<b>AMENDMENT OF SOLICITATION/MODIFICATION OF CONTRACT</b>			1. CONTRACT ID CODE	PAGE OF PAGES 1   3
2. AMENDMENT/MODIFICATION NO. 0002	3. EFFECTIVE DATE 21-Jan-2016	4. REQUISITION/PURCHASE REQ. NO.		5. PROJECT NO.(If applicable)

PRE-PROPOSAL INQUIRIES

REPLACE OVERHEAD ROLL UP DOOR, MOTORIZED OPENERS AND SAFETY EDGES  
AT BUILDING 7, 1742, 361, 22, 27 AT NAS CORPUS CHRISTI AND 1950 AT ALF  
WALDRON.

Sheet Reference:  
**G-103**  
 Sheet 4 of 6

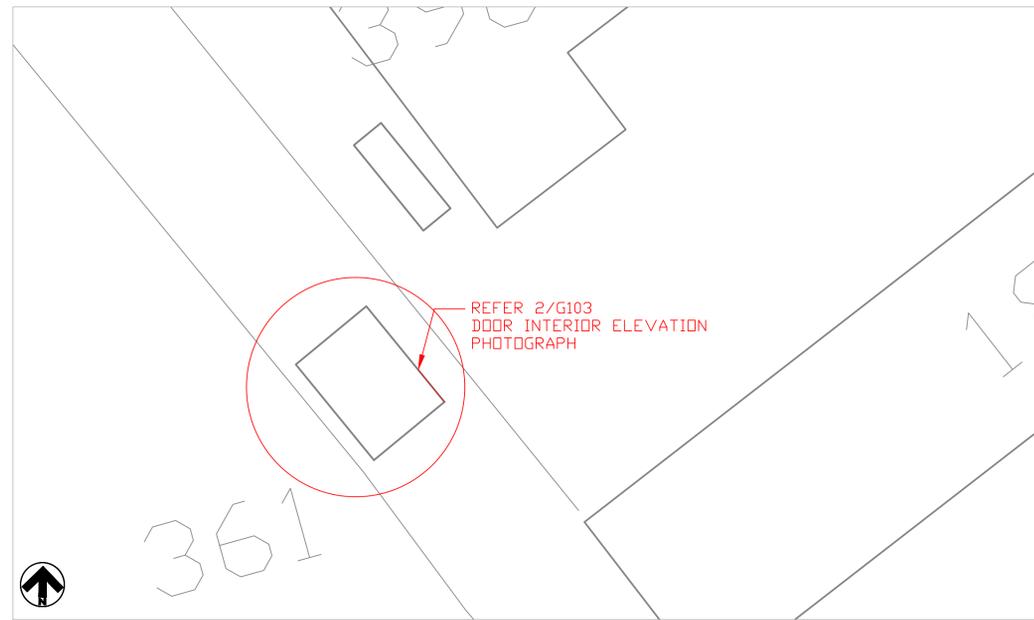
Replace Safety Edges on Bay Door #3 and #7 as well as the Motorized Door Opener #6 at Building 1742 N.A.S. Corpus Christi, Texas. Reference Attachment A sheet G-103.

Repair Damaged Left Side of Roll up Door at Building 361 N.A.S Corpus Christi, Texas. Reference Attachment A sheet G-103.

1. Install safety control and de-energize prior to any electrical work.
2. Remove 2(two) safety edges to the door #3 and #7. The safety edges shall be approximately 14' (feet) in length and have a function to reverse in an event it encounters object.
3. Remove and replace 1 (one) door opener to the door #7. New door opener shall be 1 HP 208/230/460 volts 3-phase with hoist and brake.
4. Contractor shall ensure and make all repairs necessary to make new safety edges and new opener to be fully functional/operational.
5. Dispose of off-site removed openers and safety edges. The site shall be cleaned after the completion of work.

1. Detach the hinges to separate the bottom damaged "section" panel from upper panel.
2. The section panel dimensions are approximately 28" (inches) in height and 12' (feet) wide.
3. Install new panel with new rollers, horizontal reinforcement steel strut 12' (feet) wide and bottom seal. Existing hinges can be re-used to attach new panel.
4. The new panel shall be inserted into existing track and aligned properly for the door to open and close smoothly.
5. Dispose of off-site removed panel and the site shall be cleaned after the completion of work.
